<b>JRPP No</b>	<b>2011SYW044</b>
<b>DA Number</b>	<b>DA0110/11</b>
<b>Local Government Area</b>	<b>Ku-ring-gai Council</b>
<b>Proposed Development</b>	<b>Demolition of existing dwellings and construction of two residential flat buildings comprising 43 units, landscaping and associated works.</b>
<b>Street Address</b>	<b>6A &amp; 8 Buckingham Road Killara</b>
<b>Applicant/Owner</b>	<b>Aleksandar Design Group Pty Ltd</b>
<b>Number of Submissions</b>	<b>10</b>
<b>Recommendation</b>	<b>Refusal</b>
<b>Report by</b>	<b>Jonathan Goodwill, Executive Assessment Officer</b>

<b>REPORT TITLE:</b>	6A & 8 Buckingham Road, Killara
<b>LOT &amp; DP:</b>	Lot 3 & 4 DP 414101 (6A Buckingham Road) Lot 1 DP 414101 (8 Buckingham Road)
<b>PROPOSAL:</b>	Demolition of existing dwellings and construction of two residential flat buildings comprising 43 units, landscaping and associated works.
<b>DEVELOPMENT APPLICATION:</b>	DA0110/11
<b>WARD:</b>	Gordon
<b>APPLICANT:</b>	Aleksandar Design Group Pty Ltd
<b>OWNER:</b>	<ul style="list-style-type: none"><li>- 6A Buckingham Road: Mrs C A M Grundy</li><li>- 8 Buckingham Road: Mr J T L Gilroy and Mrs F M Gilroy</li></ul>
<b>DATE LODGED:</b>	10 March 2011
<b>ESTIMAT

**Figure 1 - when measured from the finished ground level of the courtyard of apartment 4 the wall plane has an area of 174m<sup>2</sup> before stepping back at the top floor level. This wall plane includes the open terrace on Level 2 and three balconies on Levels 3-5.**

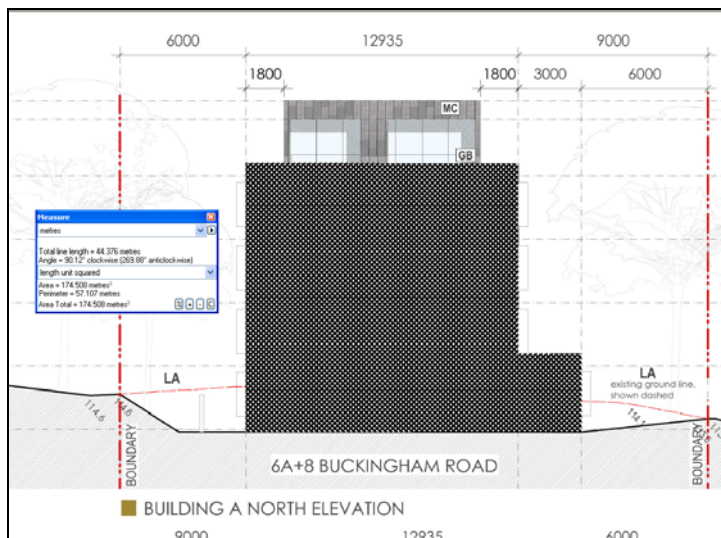
All facades to the public domain are required to be articulated with wall planes

varying in depth by not less than 600mm. Wall planes are not permitted to exceed an area of 81m<sup>2</sup>. Various methods of calculating the maximum wall plane area of the front elevation are illustrated on the diagrams below:

The variation to the wall plane depth and wall plane area controls is unacceptable because the development fails to achieve a visual connection between the dwellings and the public domain and the elements of the articulation do not have a strong relationship to the characteristics of existing buildings in the area. The primary concern is that the development fails to include a pedestrian entry that is visible from the street. The development could be improved by incorporating a pedestrian entry into the centre of Level 3. This option would avoid the need for a stair ascender at the side of the building and an access ramp could be centrally located in the front setback area. This option would give the development a clear identity and street address whilst improving safety through minimising entrapment and concealment spaces.
